Project	IEEE 802.16 Broadband Wireless Access Working Group < http://ieee802.org/16 >	
Title	Fix for ARQ Reset flow charts	
Date Submitted	2006-09-22	
Source(s)	Lavi, Nadav Alvarion	Voice: +97236457834 Fax: +97236456222 [mailto:nadav.lavi@alvarion.com]
Re:	Supporting contribution for Maint TG Change request	
Abstract		
Purpose	For consideration by Maint TG	
Notice	This document has been prepared to assist IEEE 802.16. It is offered as a basis for discussion and is not binding on the contributing individual(s) or organization(s). The material in this document is subject to change in form and content after further study. The contributor(s) reserve(s) the right to add, amend or withdraw material contained herein.	
Release	The contributor grants a free, irrevocable license to the IEEE to incorporate material contained in this contribution, and any modifications thereof, in the creation of an IEEE Standards publication; to copyright in the IEEE's name any IEEE Standards publication even though it may include portions of this contribution; and at the IEEE's sole discretion to permit others to reproduce in whole or in part the resulting IEEE Standards publication. The contributor also ack

Figure 34-ARQ Reset message dialog-transmitter initiated

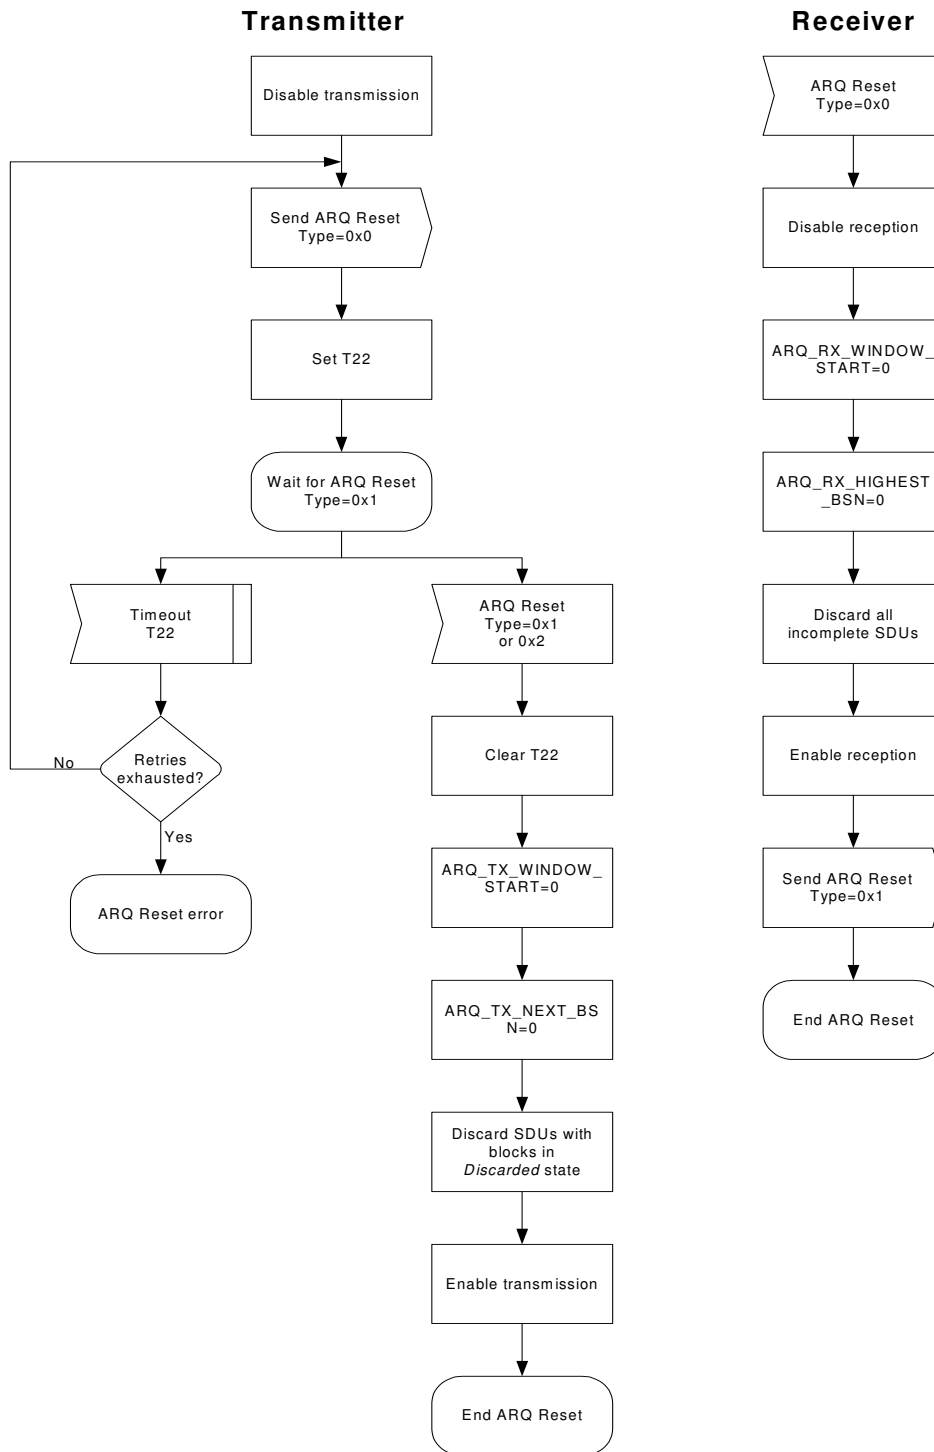
Figure 34 in 802.16e-2005 is incomplete:

- resetting of parameters ARQ_TX_NEXT_BSN and ARQ_RX_HIGHEST_BSN is missing

[At the page 177 of 802.16e-2005 replace Figure 34 with the following figure]

Figure 35-ARQ Reset message dialog-receiver initiated

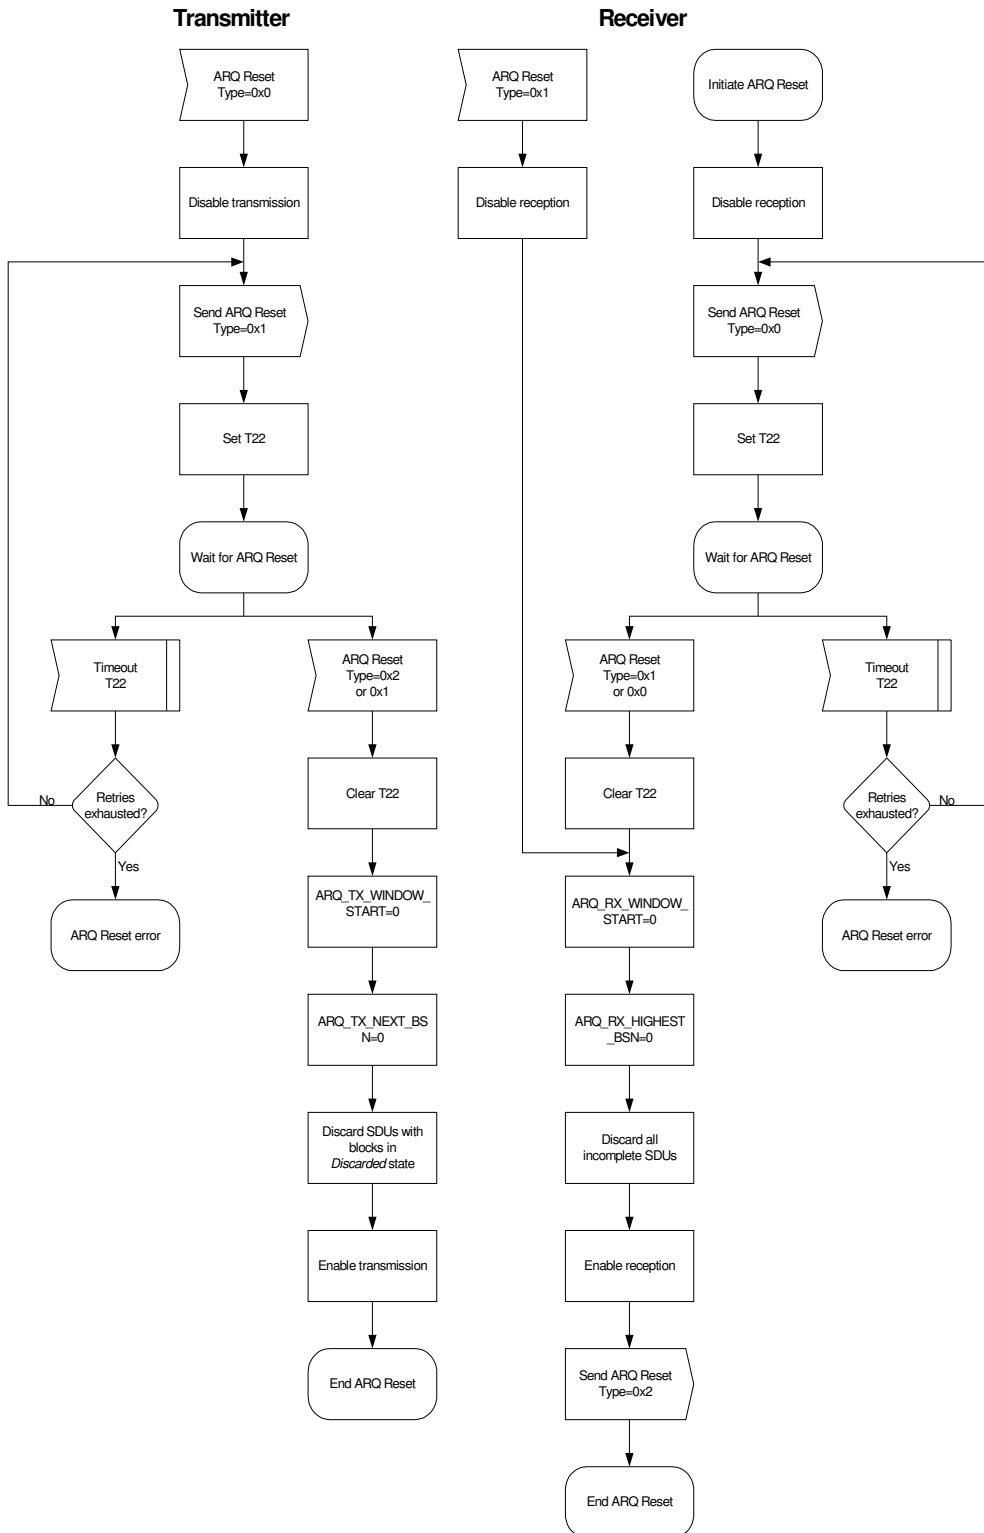
Figure 35 in 802.16e-2005 is incomplete and contains errors:

- resetting of parameters ARQ_TX_NEXT_BSN and ARQ_RX_HIGHEST_BSN is missing

[At the page 178 of 802.16e-2005 replace Figure 35 with the following figure]

Replace Figure 35 with the following figure:
